Addendum # 1

BID NO.: 101270
OPENING: 6/1/23 @ 12:00 PM
COMMODITY: TOOTELL DIVING WELL RESURFACING

ADDENDUM NO. 1 – 5/18/2023

URI - TOOTELL AQUATIC CENTER DIVING POOL RESURFACING

DP-7

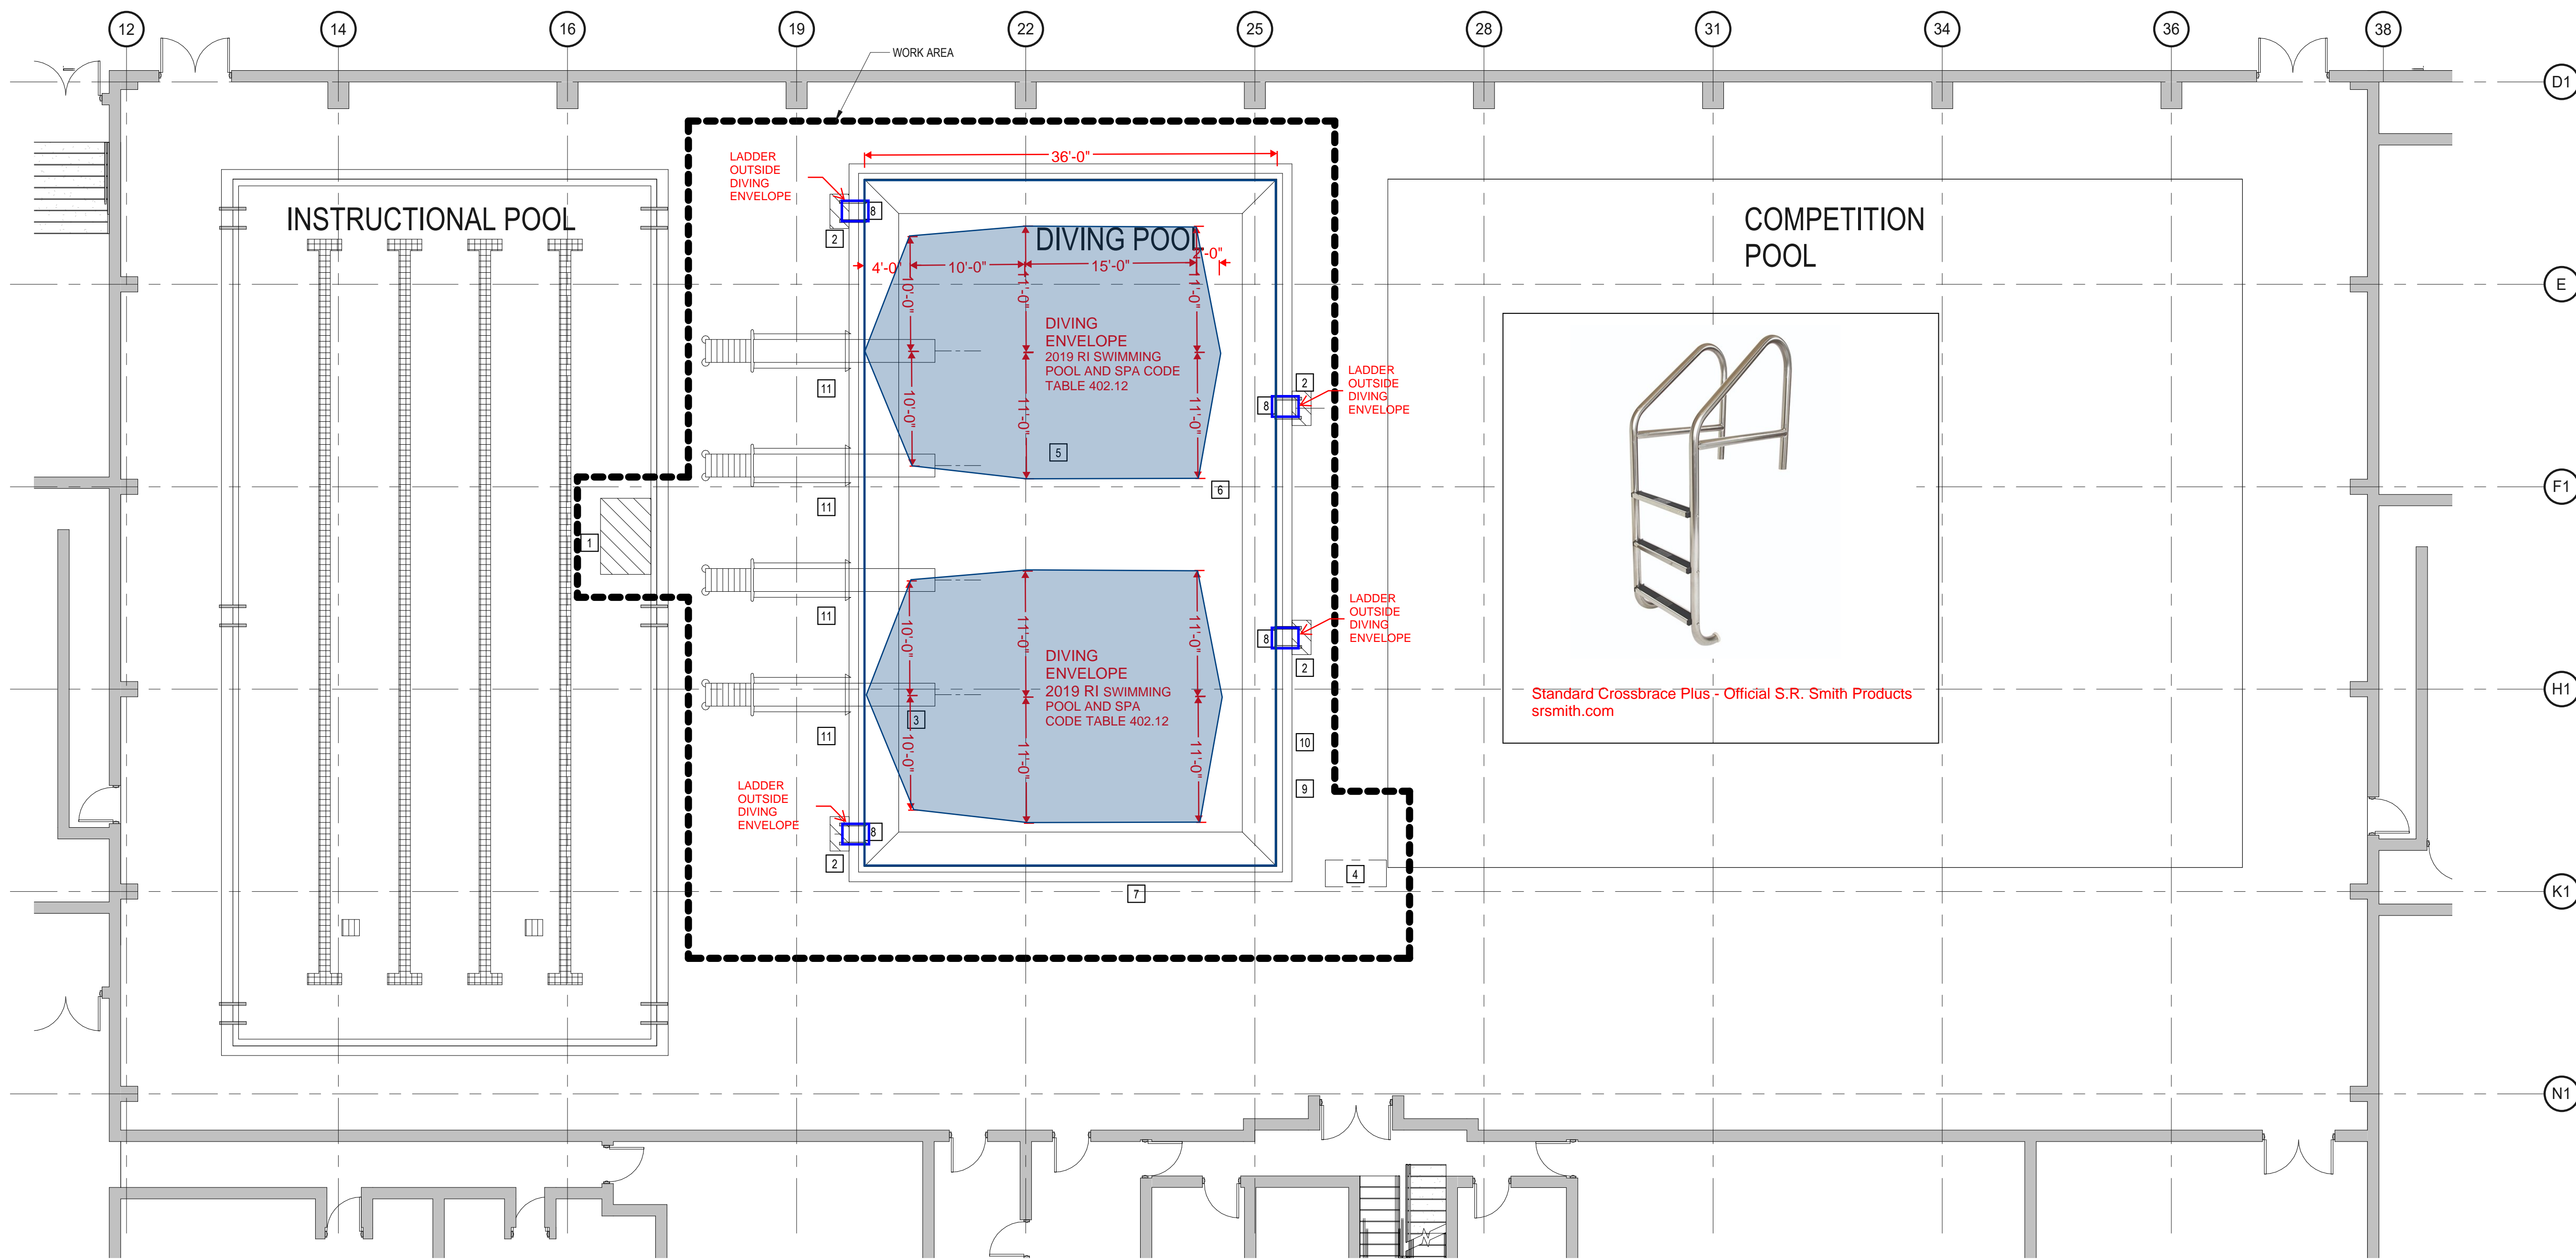
- 1. DRAWING #DP-1
Revise last sentence of demolition key-note 8 as follows:
“Remove four (4) existing grab rails. For replacement grab rails see construction notes and drawing DP-7.”
- 2. DRAWING #DP-2
Delete construction key-note 6 and replace with the following:
“Provide and install four (4) new ladders: Standard Crossbrace Plus, Official SR Smith Product. Specifications – Tubing: 1.9” OD, 0.145” wall thickness; Type: 304 stainless steel; Number and material of treads: 5, stainless steel; Radius bends: 6”. Treads shall be set at 1’- 0” o.c. and the dimension between the top tread and the pool deck shall be 1’- 0”. See also drawing DP-7.
- 3. DRAWING #DP-3
Delete details “Grab rail with steps.”
- 4. DRAWING #DP-7
Add attached drawing DP-7 “Diving Envelope and Replacement Ladder”.
